Model: RL

Subject: HYP00182 Piggyback Pump Replacement

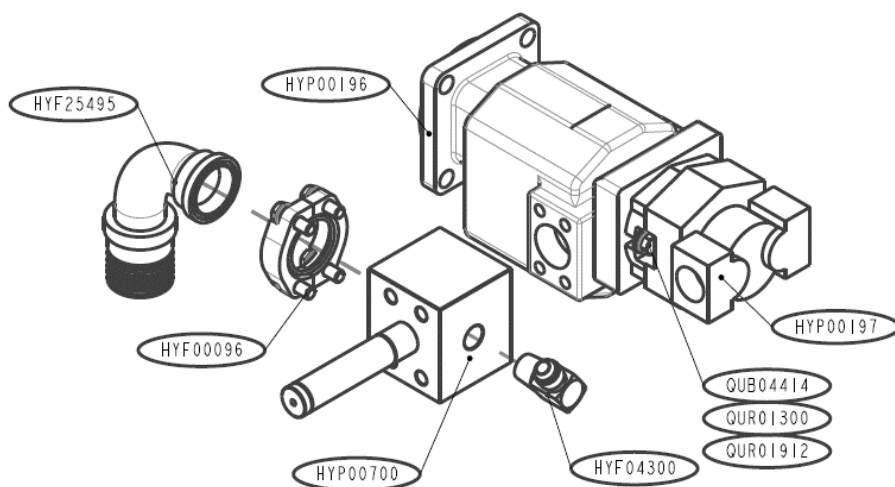
The HYP00182 piggyback pump used on Leach Rear Loaders has been discontinued by the supplier. SERV02903 has been created to replace HYP00182. The kit includes a new pump assembly, dry valve and associated fittings needed to convert from the HYP00182 pump since the suction port is now 2" on the new pump.
